LEMOORE PLANNING COMMISSION
Special Meeting
AGENDA
Lemoore Council Chamber
429 'C' Street

To: Lemoore Planning Commission **Item No. 8**
From: Judy Holwell, Community Development Director
and Steve Brandt, City Planner
Date: February 19, 2021 **Meeting Date:** February 22, 2021
Subject:

Adoption of Resolution No. 2021-01 for Planned Unit Development No. 2020-03, Revision of Fairway Courtyards Tentative Subdivision Map 2020-02, and Major Site Plan Review No. 2020-05: A request by GJ Gardner Homes to divide 4.59 acres into 29 single-family lots and three outlots. The project is located on the east side of Vine Street, approximately 400 feet south of Iona Avenue in the City of Lemoore (Currently APNs: 024-390-001 through 024-390-042). A Categorical Exemption has been prepared in accordance with the California Environmental Quality Act.

To: GJ Gardner Homes
From: Steve Brandt, City Planner
Date: February 16, 2021
Subject: Planned Unit Development No. 2020-03, Revision of Fairway Courtyards Tentative Subdivision Map 2020-02, and Major Site Plan Review No. 2020-05: A request by GJ Gardner Homes to divide 4.59 acres into 29 single-family lots and three outlots. The project is located o

Drainage Basin

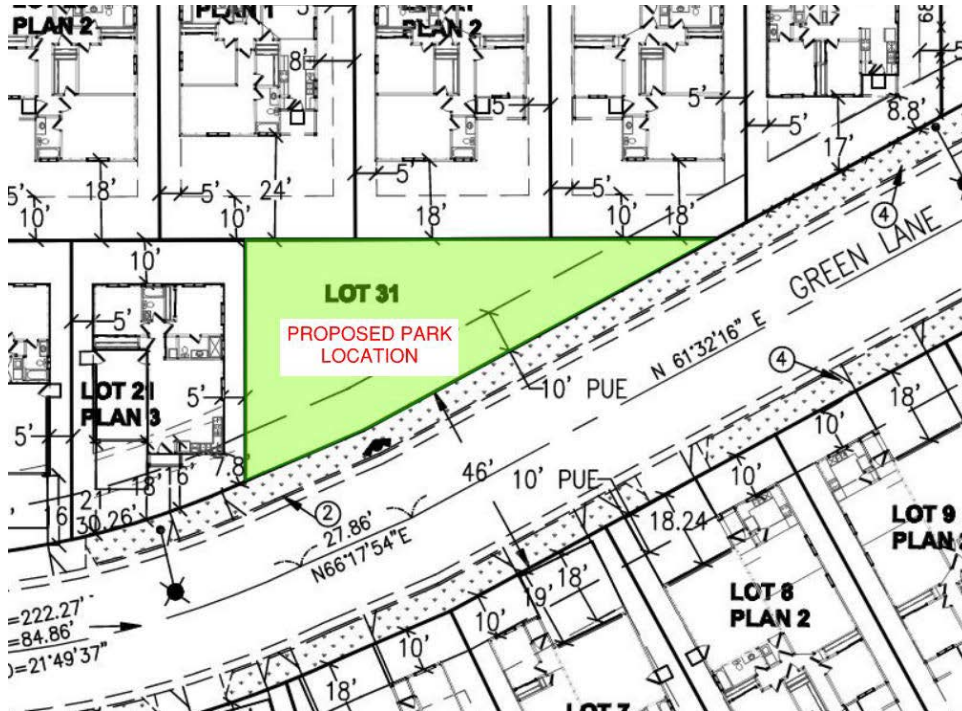
The triangular-shaped Storm Drain Basin will be fully enclosed with six-foot high wrought iron fencing on the south and west sides and a seven-foot high stucco CMU wall on the north. Maintenance Access to the basin will be via two six-foot wide wrought iron swing gates located on the east end of the Sandtrap Lane cul-de-sac at the designated approach apron and immediately adjacent the back of the proposed landscape buffer.

The applicant proposed a chain-link fence between the street and the basin. However, staff is recommending a condition that the fence and gates be constructed of the same powder coated wrought iron as that of the existing golf course fences. A 5' landscaped area is required between the back of the cul-de-sac sidewalk and the proposed fence line on the west edge of the ponding basin area.

Park Location

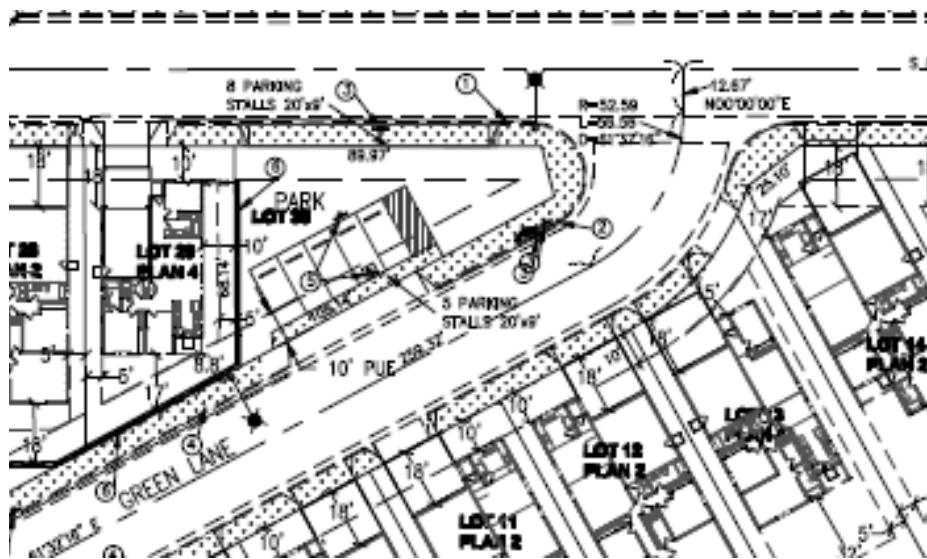
Park: The park, shown on the plan as Lot 31, will be built to City standards by the developer and dedicated to the City when completed. Maintenance will be funded through a public facilities maintenance district (PFMD). The applicant has submitted a concept plan for landscaping of the park. Staff is recommending the proposed park be ADA compliant and include a minimum of one tot lot play structure suitable for 2-5 year olds, two park benches, one picnic table, shade trees, landscaping and access walk/walks connecting benches, table, play structure and the street. The park and all included

The Lemoore Municipal Code requires 0.016 acres per single-family lot to be dedicated as park land with a new subdivision. The 29 lots would require 0.464 acres (or 20,212 sq.ft.) of park acreage. Based on the draft Tentative Subdivision Map submitted November 5, 2020, the park is approximately 3,128 sq.ft. Since the actual landscaped acreage of the park is less than 0.464 acres, the remaining acreage required for the Ordinance shall be provided through an in-lieu fee with the amount based on an appraisal of residentially zoned properties performed by an appraiser approved by the Community Development Director in accordance with City Ordinance Section 8-7N-4. The cost of the appraisal shall be paid by the developer. A condition is being recommended that up to \$7,500 in park in-lieu fees be credited toward the cost of the tot lot play structure.

Location of enhanced wood fence

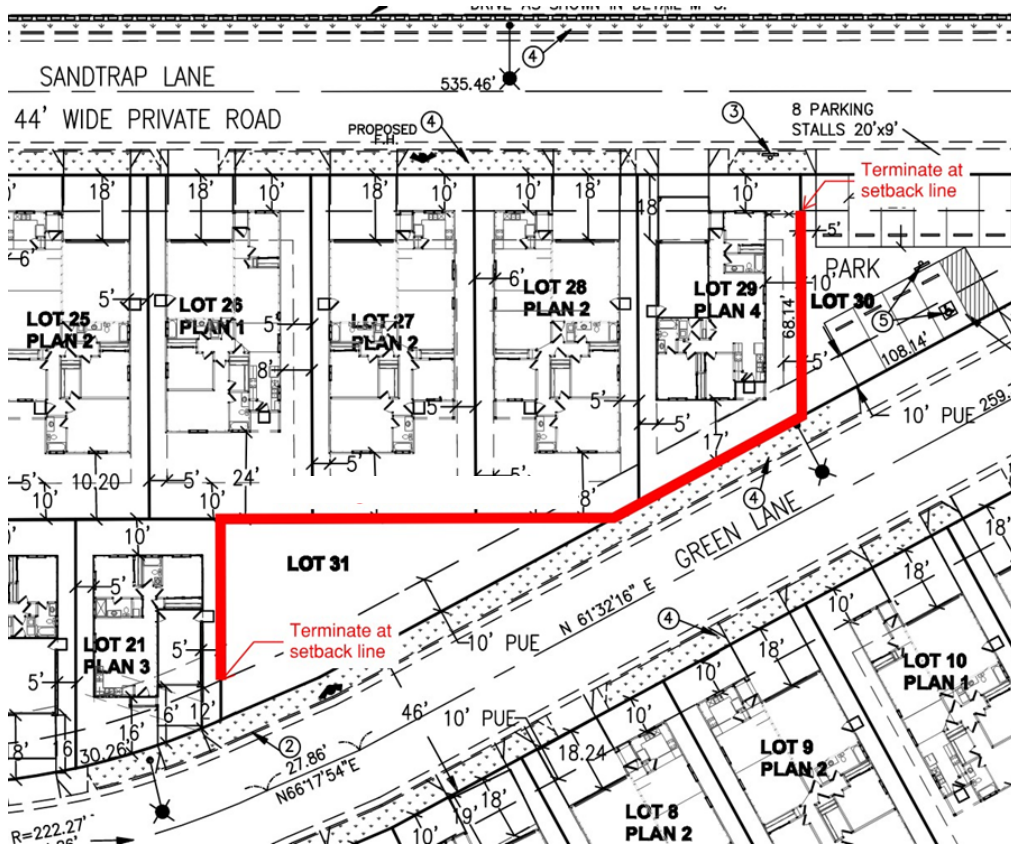
Staff is recommending enhancements to the wood fence separating the residential living spaces from the proposed park and parking lot (Lots 30 and 31). This is because the City will be responsible for maintenance of the fence over time. The recommendation is that a continuous concrete mow strip be placed along the fence line, and that the fence posts be constructed of metal or concrete. This will lengthen the fence's lifespan before needing replacement.

ENGINEERING

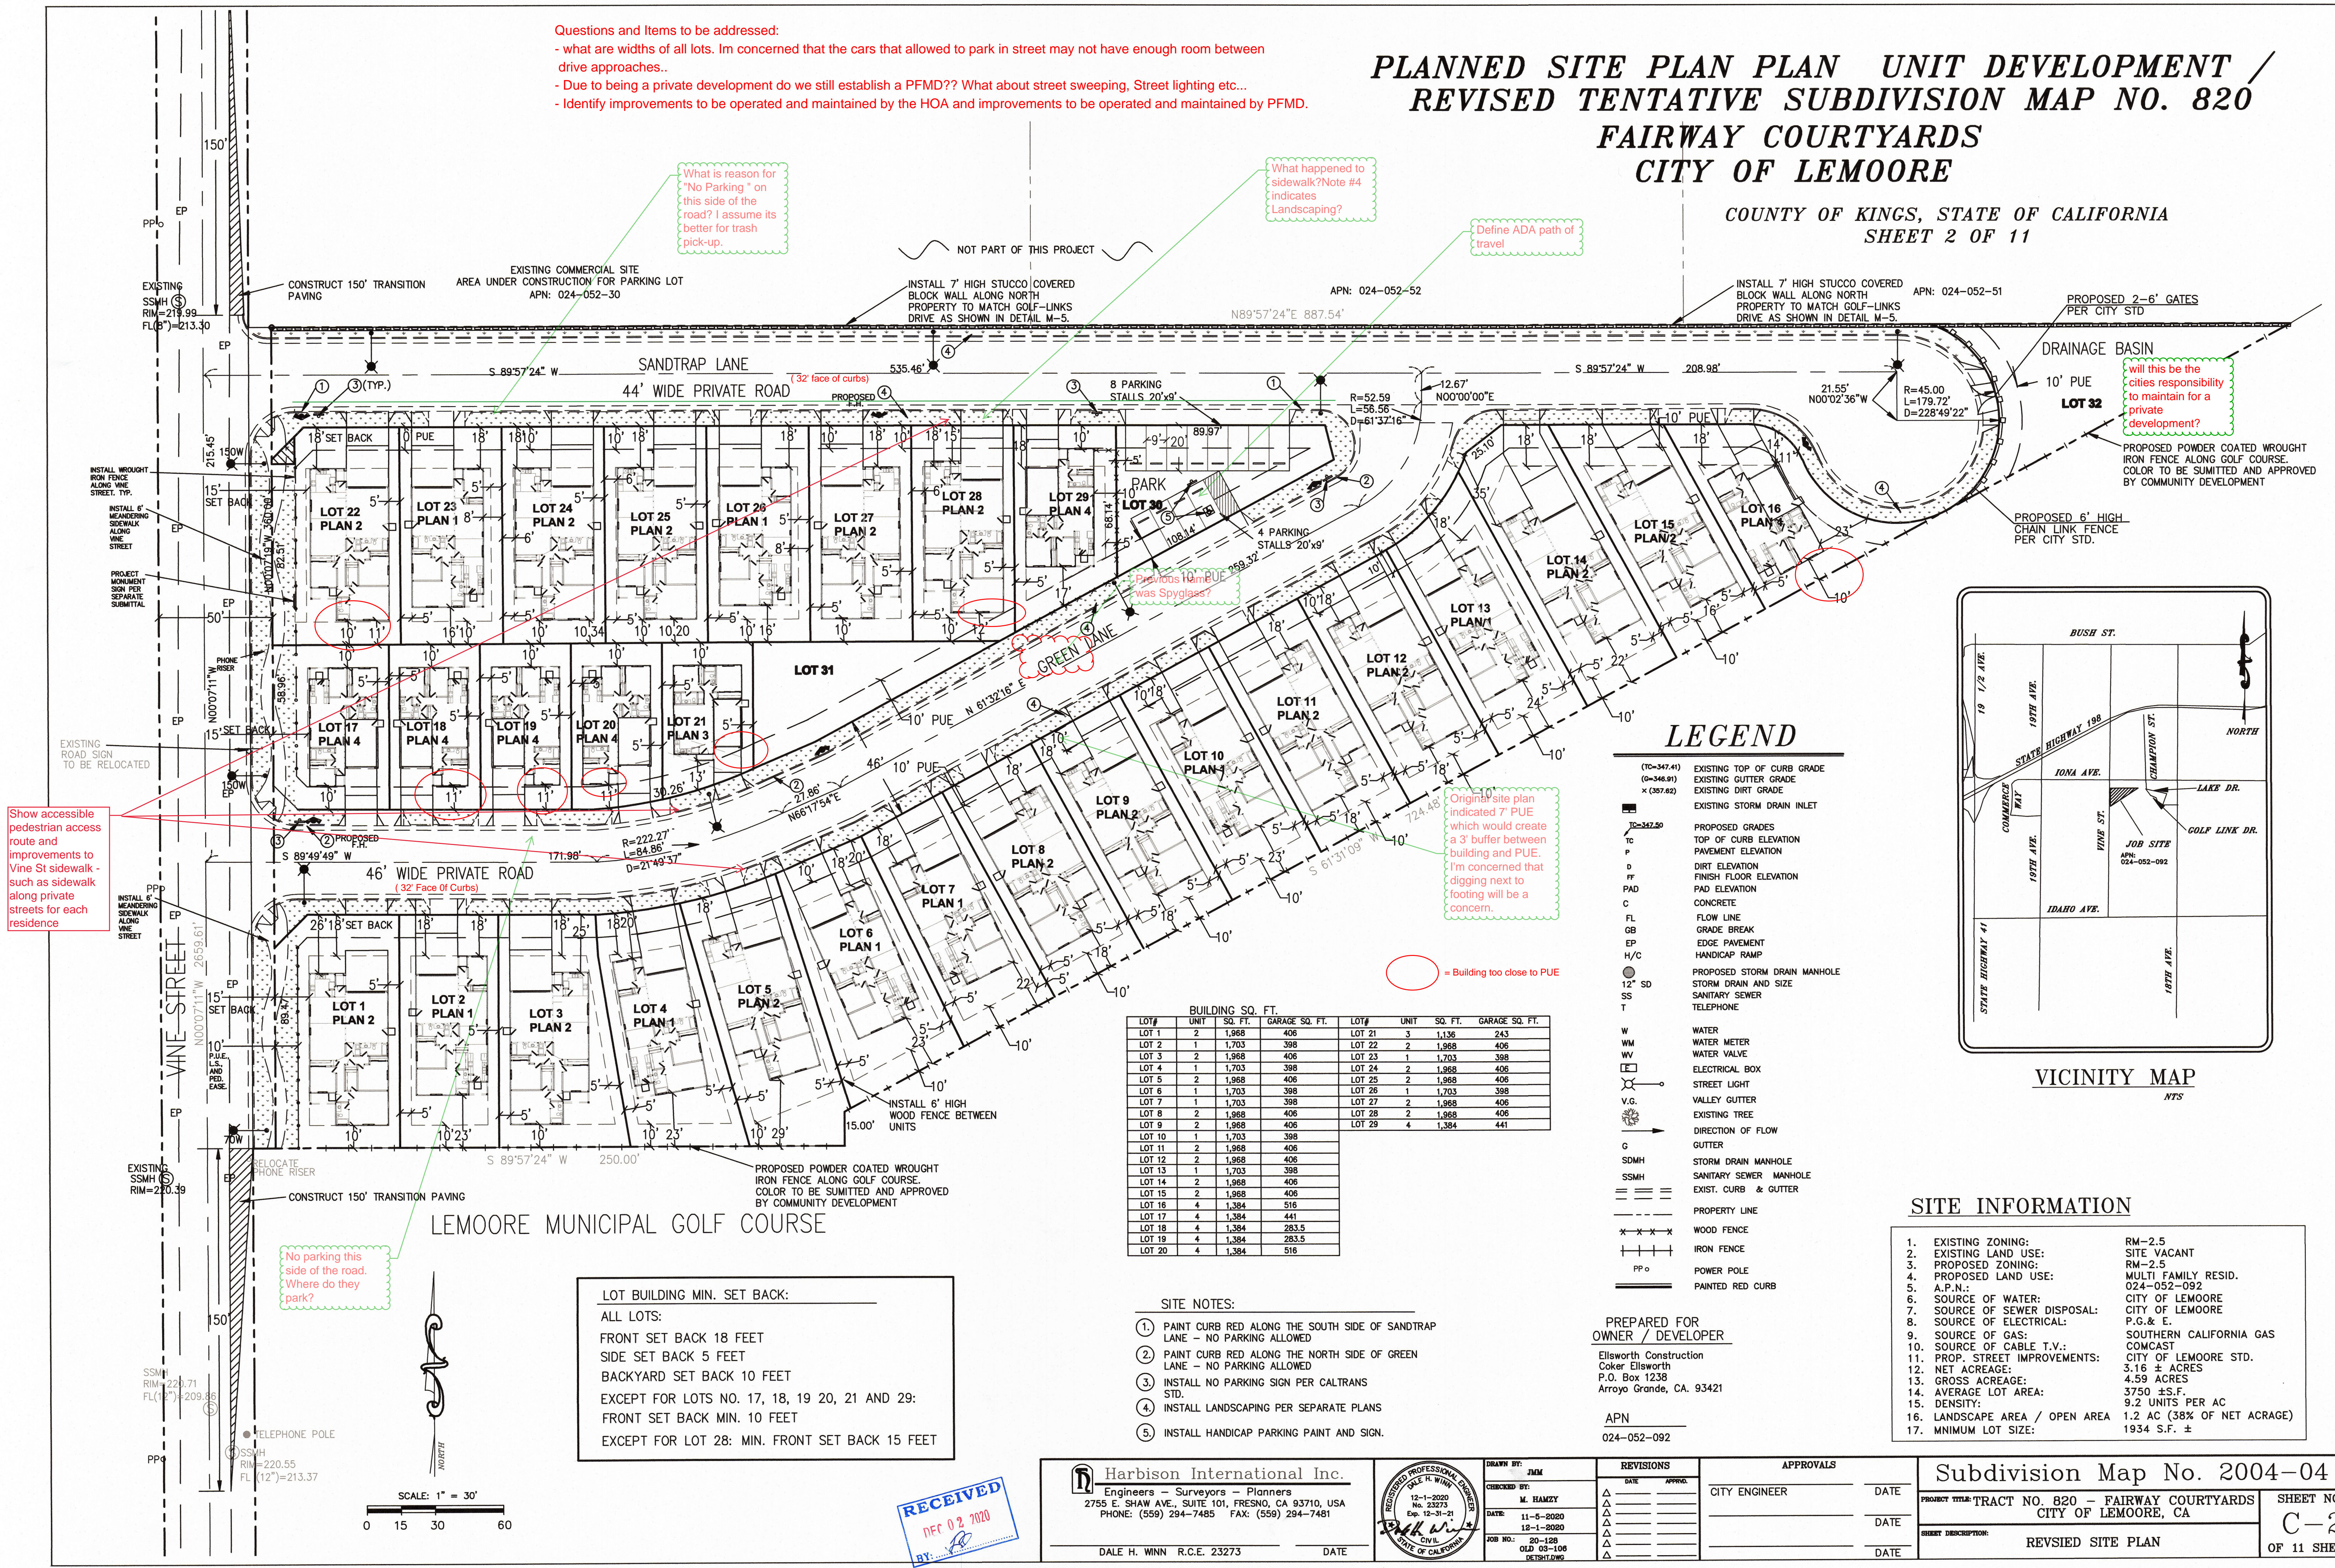
- ☐ Comply with prior comments
- ☒ Resubmit with additional information – show lot dimensions, show pedestrian access pathway for each residence to Vine Street (such as sidewalk along the private street); Review No Parking along Sandtrap Lane and consider moving it to the north side

1. Developer shall show all existing improvements constructed on-site per the previous Tract 820. Developer shall confirm that any existing improvements intended to be used have been tested and checked to the satisfaction of the City Public Works Director and City Engineer prior to being allowed to remain and be used.

2. Developer shall remove and replace any existing improvements that are not acceptable to the City for use in the development and/or do not match the revised final map and improvement plans.
